LBK-ADDs Schematic

DDQ12/LA1901 Schematic with Capture CIS and Function field
uFCPGA Banias
06-24-2003
REV: 1.0

DELL CONFIDENTIAL/PROPRIETARY		
Compal Electronics, Inc.		
Title		
Cover Sheet		
Size	Document Number	Rev
	DDQ12/11/01 with LA-1901	1.0
Date:	Thursday, July 03, 2003	Sheet 1 of 58

Title			
Odem(1 of 3)			
Size	Document Number	Rev	
C	DDQ12/11/01 with LA-1901	1.0	
Date:	Thursday, July 03, 2003	Sheet	10 of 58

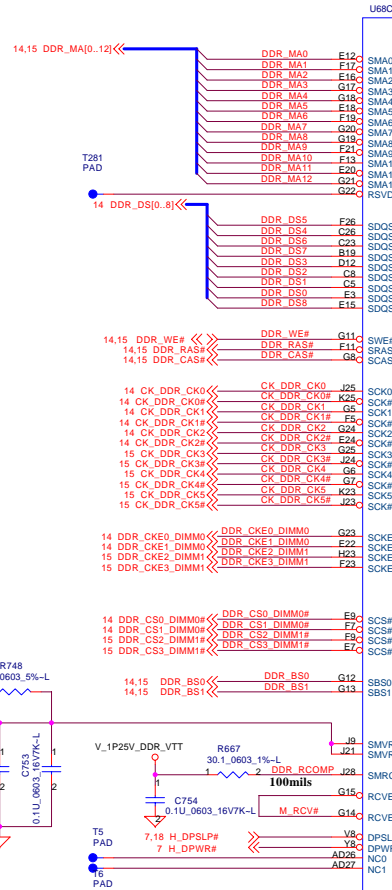
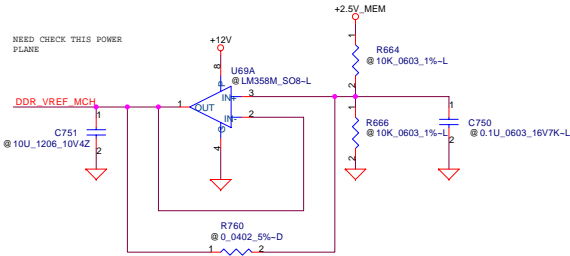
All of those schematic shall be changed to un-pop

NEED CHECK THIS POWER PLANE

NEED CHECK THIS POWER PLANE

TV_OUT and CRT			
DDQ12/11/01 with LA-1901			
Date:	Thursday, July 03, 2003	Sheet	17 of 58

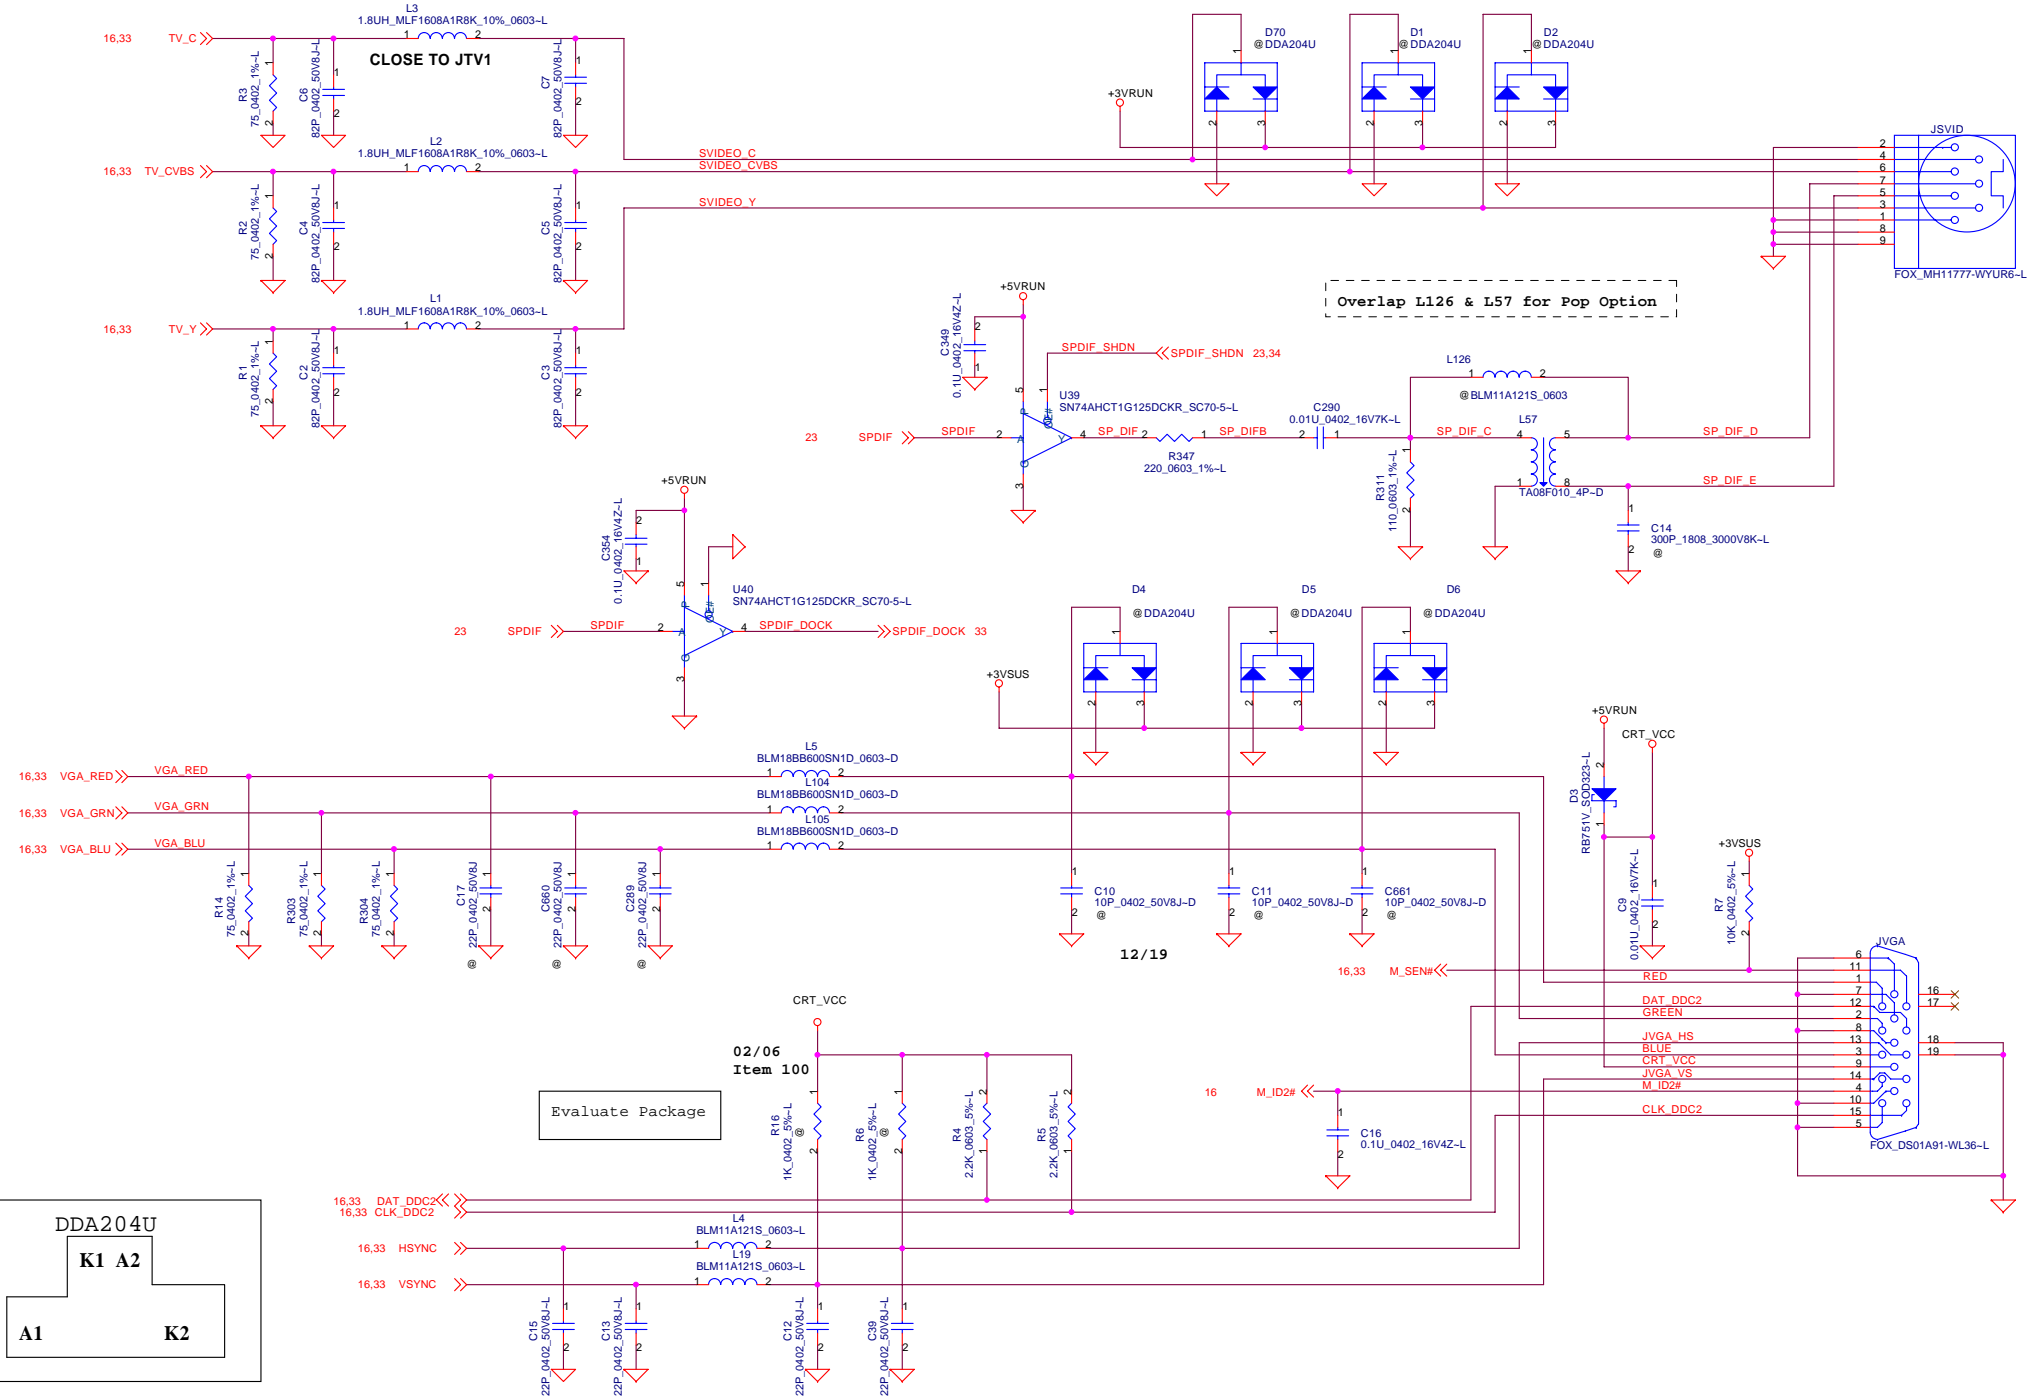
02/06
Item 100

Overlap L126 & L57 for Pop Option

Title
SCHEM,PLN,MN,KAPALUA II VCC_CORE
Size Document Number
DDQ12/11/01 with LA-1901
Date: Thursday, July 03, 2003 Sheet 47 of 58

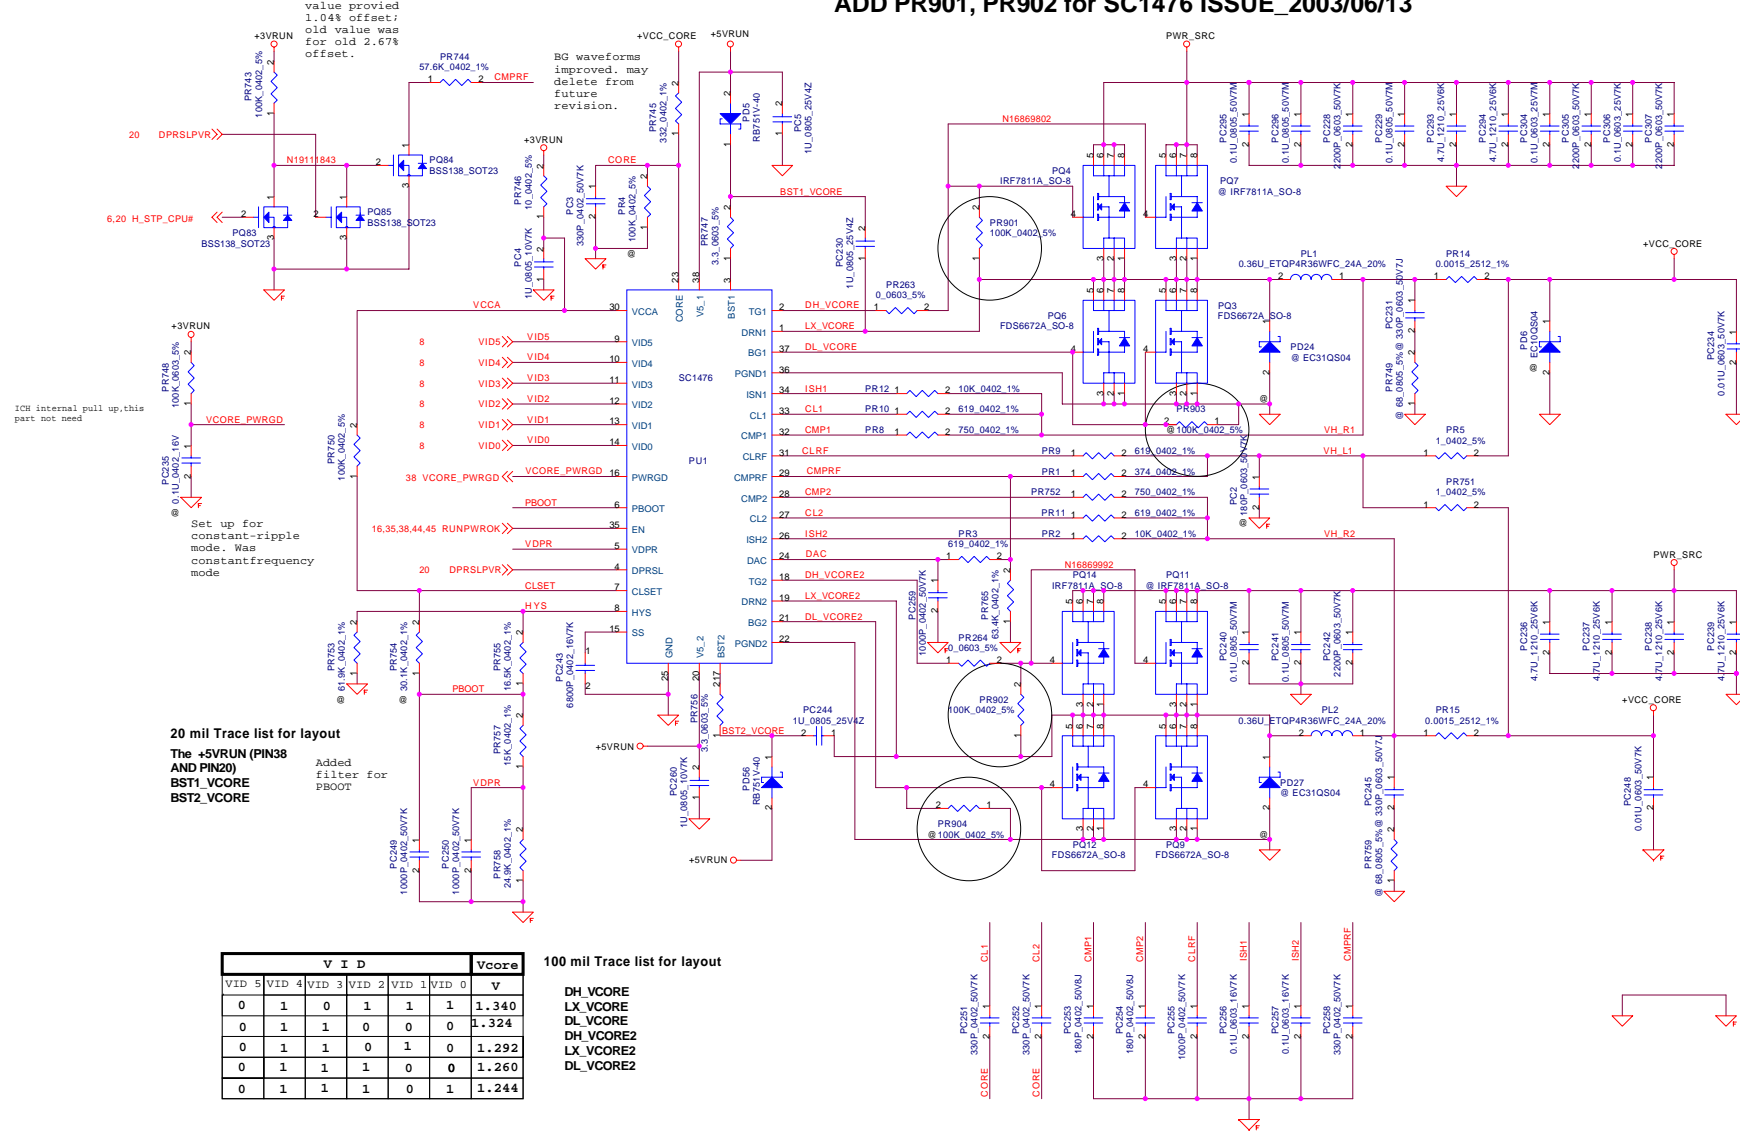
ADD PR901, PR902 for SC1476 ISSUE_2003/06/13
